ANNEXURE F (I):
STORMWATER MANAGEMENT CONCEPT

JOHNS ROAD CAR STORAGE PROJECT – SECTION 92 RESPONSE – ENGINEERING MATTERS

Review of Stormwater Management Concept

Review of Stormwater Management Concept

GENERAL ARRANGEMENT OF TYPICAL STORMWATER SOLUTION
SCALE 1:200

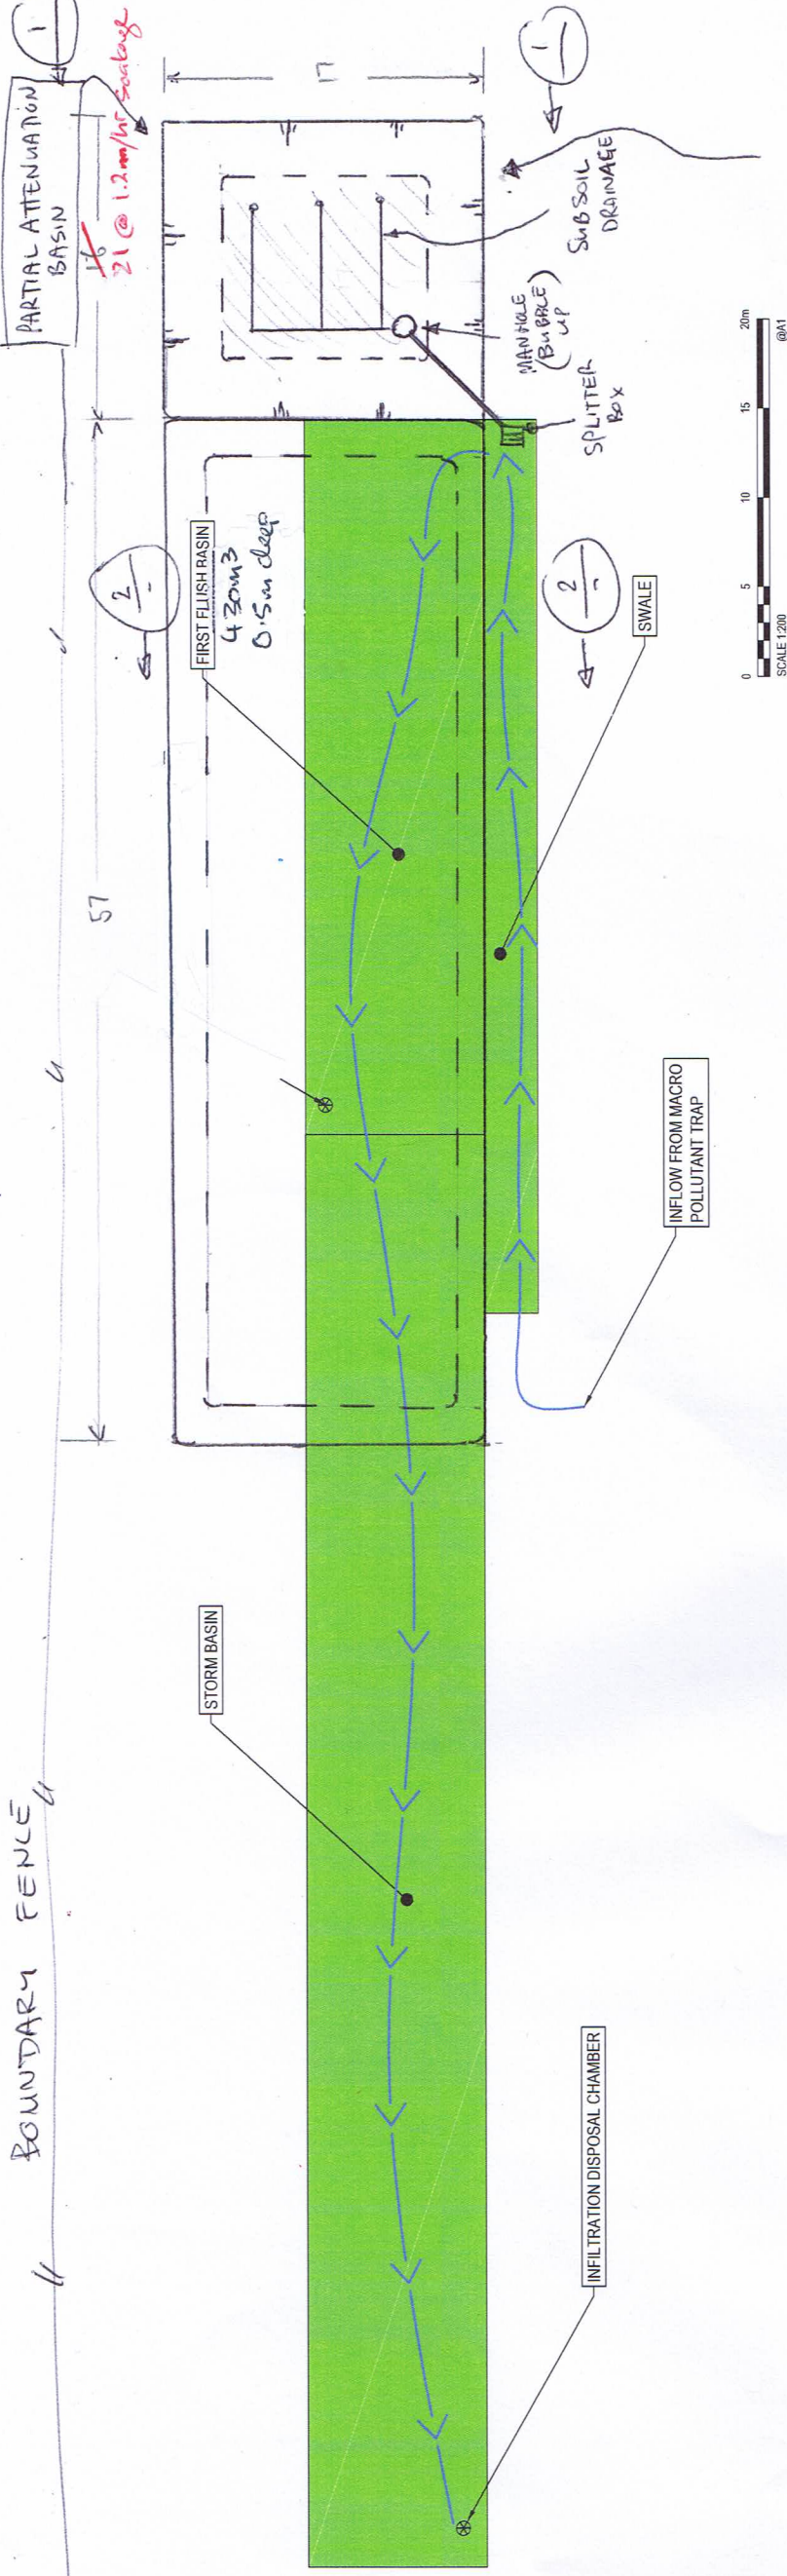
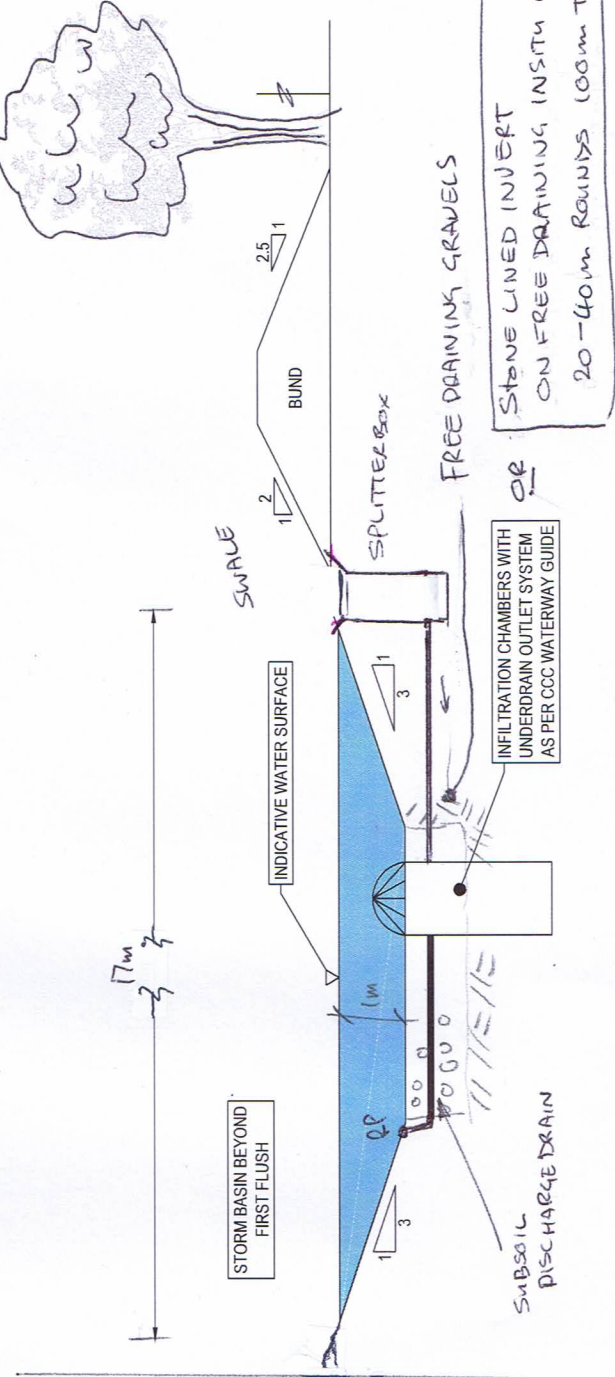
The first flush basins have been designed to be 0.5m deep. However our calculations based on a typical 1.9ha catchment suggests that the first flush basins may be slightly undersized.

We estimate that approximately 40% of additional land will be required over and above what has been shown on the previous concept. This excludes additional area required for free board or if the basin inverts need to be lowered to match into grades required to achieve drainage from pavement catchment.

A first flush basin, on the 1.9ha catchment, with invert dimensions of 14m x 54m would discharge the first flush volume in just under 24 hours (at a design soakage rate of 25 mm/hr). Calculations and sketches are included in Appendix A.

Our recommendation is that the attenuation basins are modified to utilise the soakage potential of the in-situ soils. This may involve lining the invert with coarse gravels at a depth where free draining gravels are intercepted or installing under-drains under the basin invert (to discharge into the underlying gravels). If the invert was lined with gravel it may minimise the attraction to birds by removing vegetation that can be grazed. However, if under-drains were installed, a grassed invert might create a habitat for grazing birds but would probably be easier to maintain than gravel inverts.

For the largest 1.9ha catchment a minimum of 105m² of attenuation basin invert would be required and assuming an average soakage rate of 1,200 mm/hr a basin with invert with would be required. A sketch of this solution and calculations are included in Appendix A.

PARTIAL ATTENUATION BASIN VOLUME
150 to 5 m³
1.0m DEEP

TYPICAL STORMWATER PARTIAL ATTENUATION BASIN
NTS
